**From:** Turchy, Michael A  
**Sent:** Monday, July 7, 2025 10:05 AM  
**To:** Annino, Amy; Jamison, John  
**Cc:** Amschler, Crystal C CIV USARMY CESAW (US); McHenry, David G; Wojski, Paul A; Pjetraj, Michael; Bukowy (HNTB), Kat A  
**Subject:** RE: Request for Additional Information: DWR 20250109 V3 - Hurricane Helene I-40 Pigeon River Gorge Emergency Relief Project

**Subject:** Request for Additional Information: DWR 20250109 V3 - Hurricane Helene I-40 Pigeon River Gorge Emergency Relief Project

# TIP PROJECT: I-40 PIGEON RIVER

**S-006R3: REVISED PERMIT DRAWINGS**  
**DATE: 06/03/2025**

PROJECT REFERENCE NO. I-40 PIGEON RIVER	SHEET NO. 9
RW SHEET NO.	
ROADWAY DESIGN ENGINEER	HYDRAULICS ENGINEER
INCOMPLETE PLANS DO NOT USE FOR R/W ACQUISITION

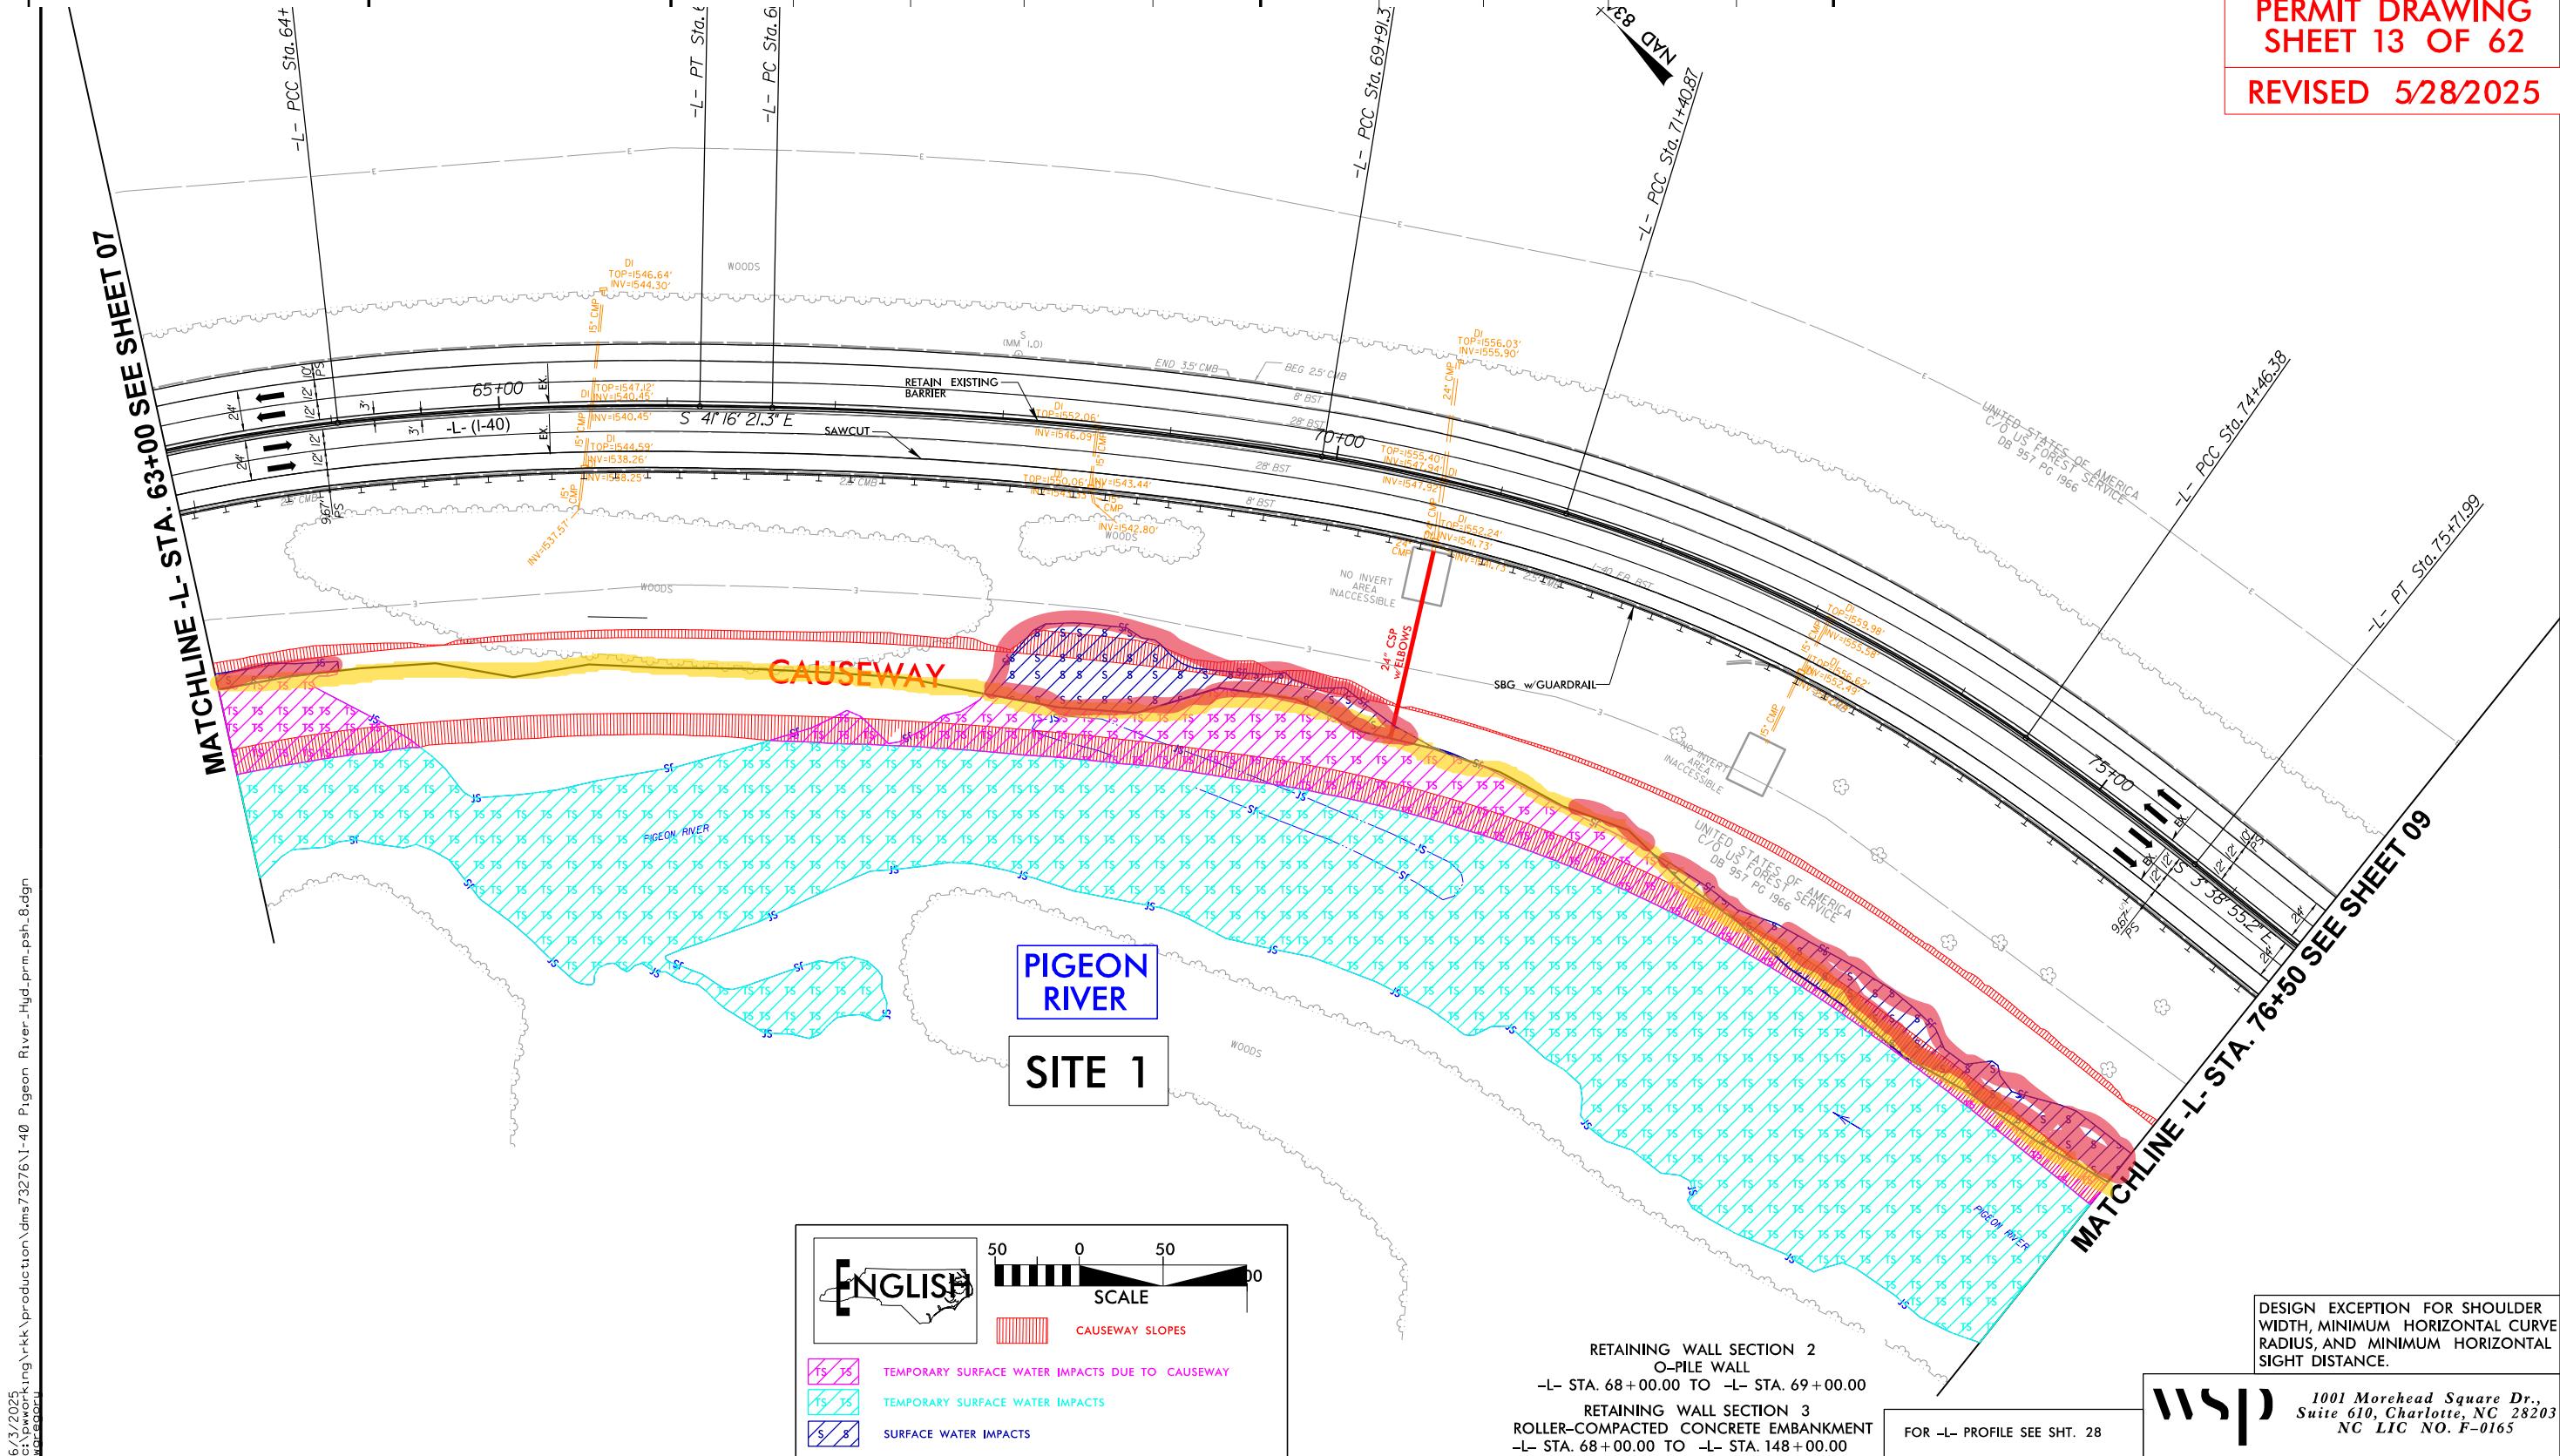
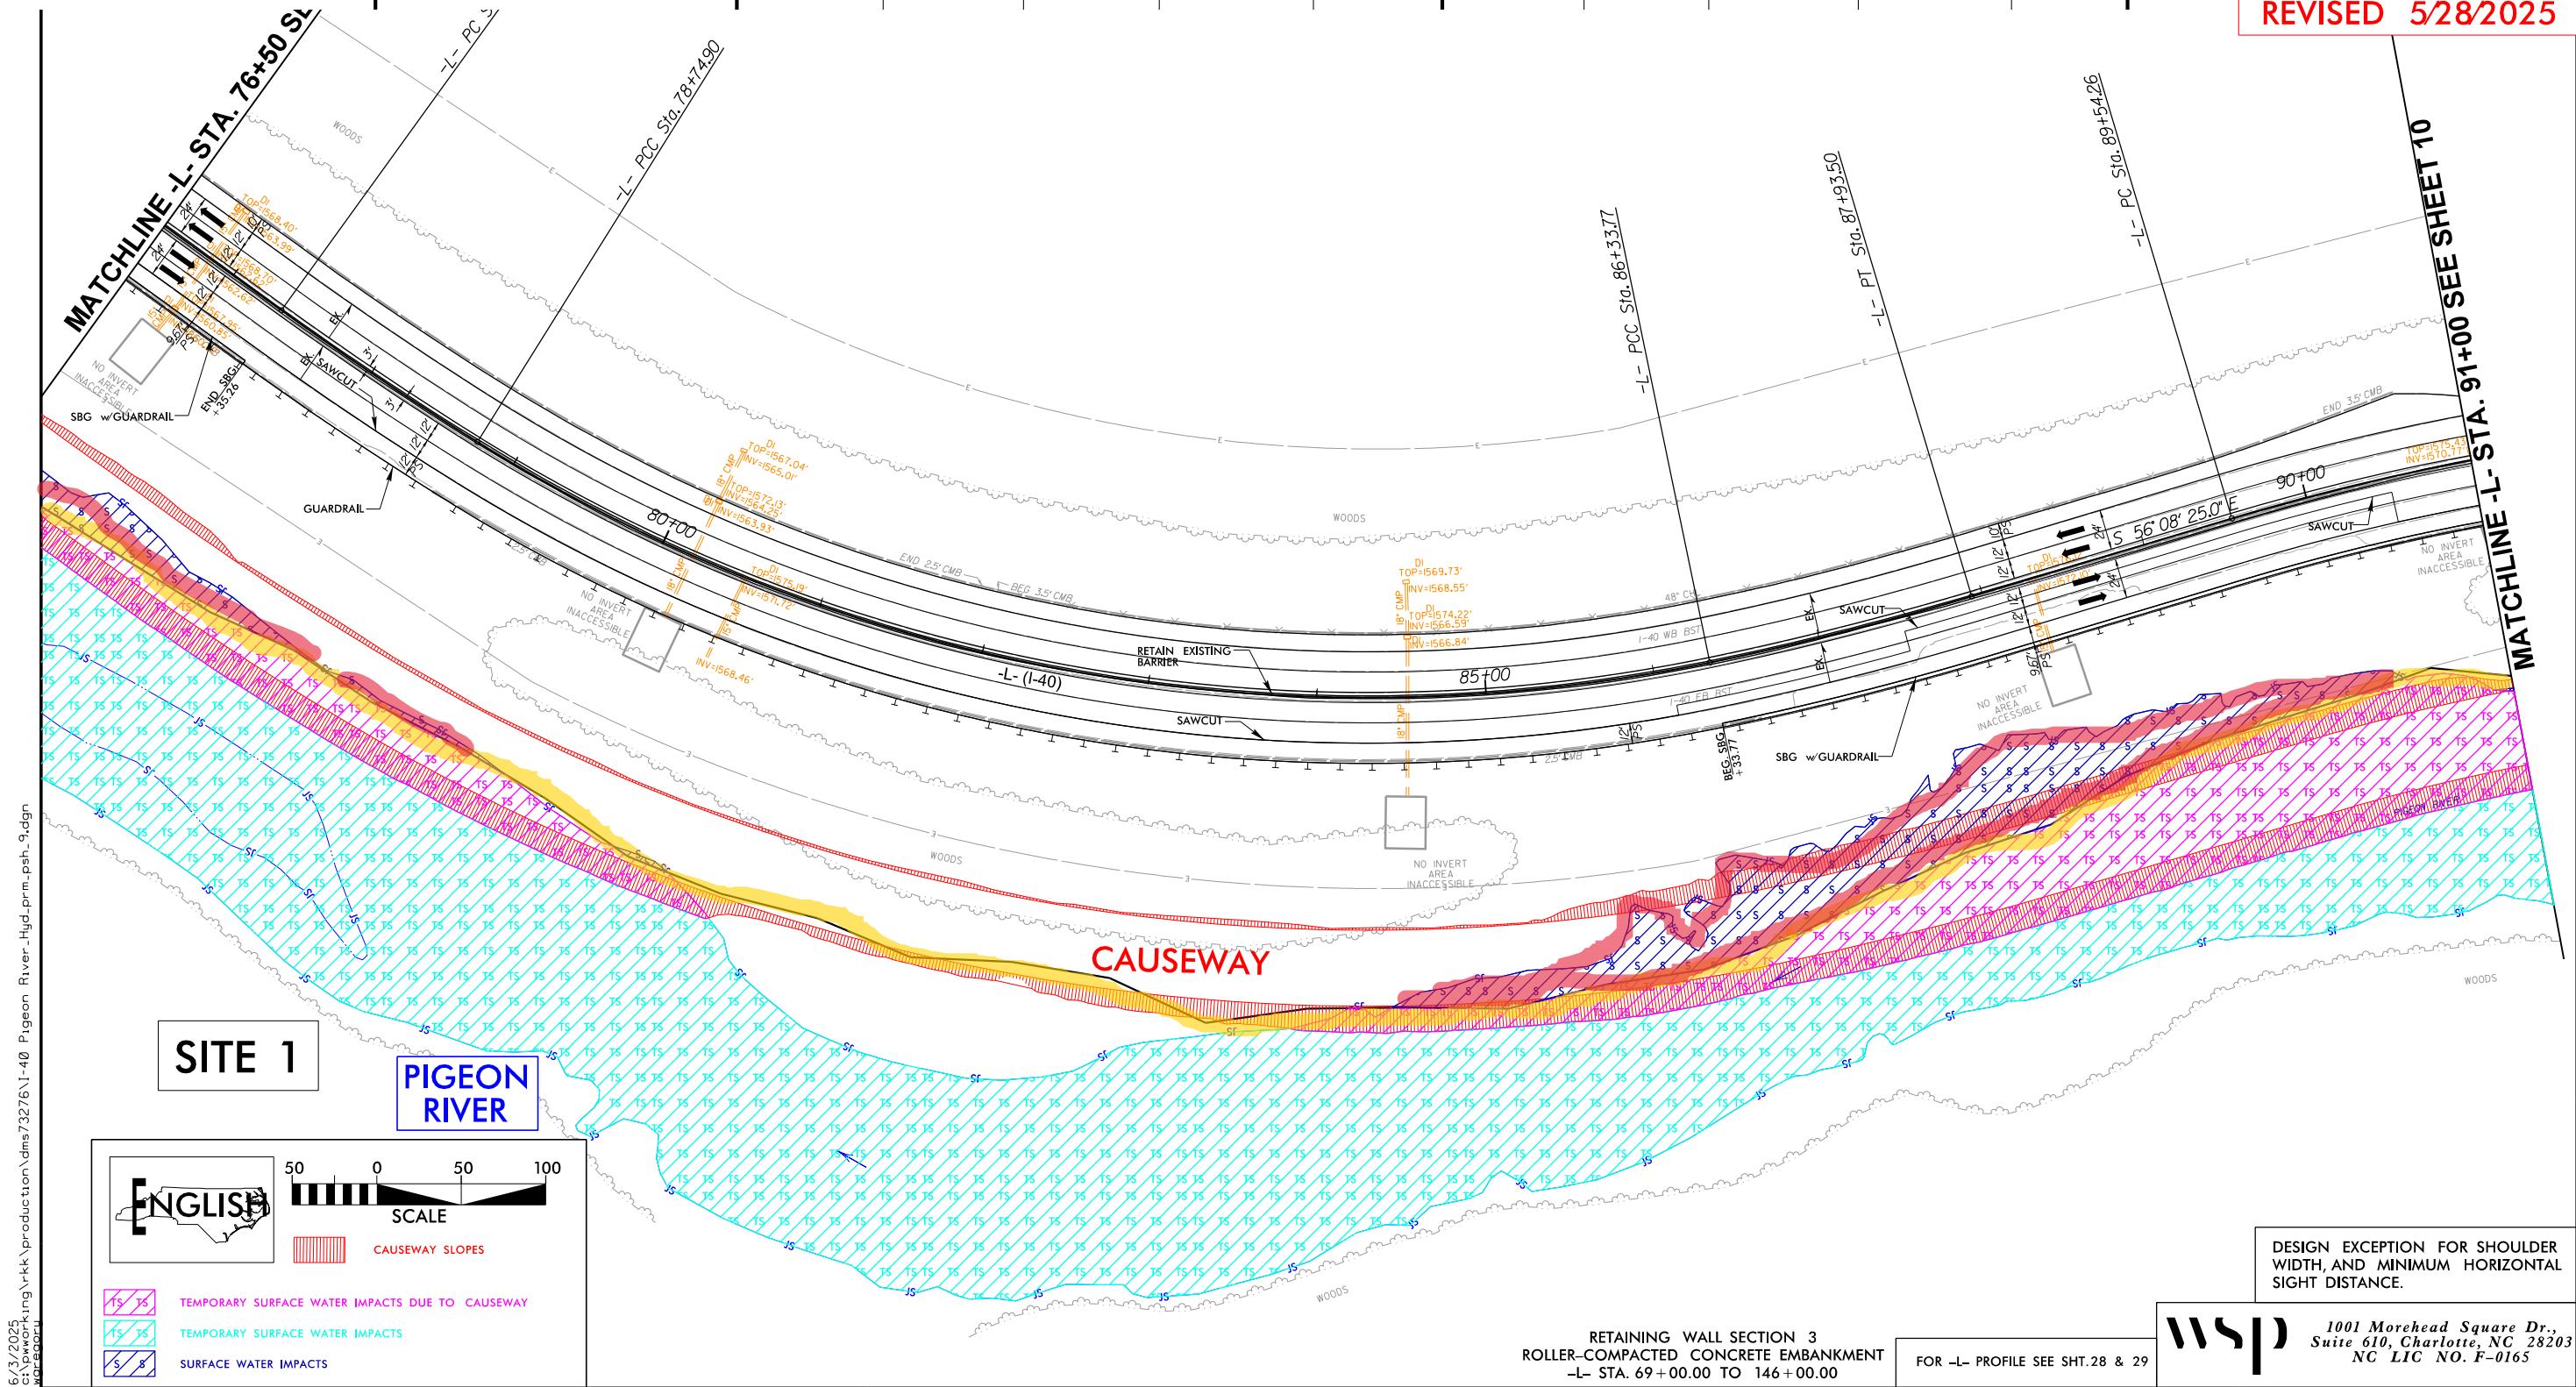
3. Please show the footprint of the proposed retaining wall through the project area

The proposed wall is located on the submitted set of drawings, and attached is a marked up set of drawings highlighting the wall for clarity, titled “**Drawings with Wall Highlighted**.”

The wall is highlighted in yellow. Wall impacts are highlighted in red.

Additionally, the impact summary table has been excerpted on each page to clarify the quantify the wall impact.

As previously noted, impacts are shown using the “scour zone limits” of the Pigeon River, as locating the ordinary high water mark post-Helene is not possible. Therefore, these drawings display a “worst case scenario” and are likely much lower than indicated.

The total proposed wall impacts to the Pigeon River are 12,116 linear feet.
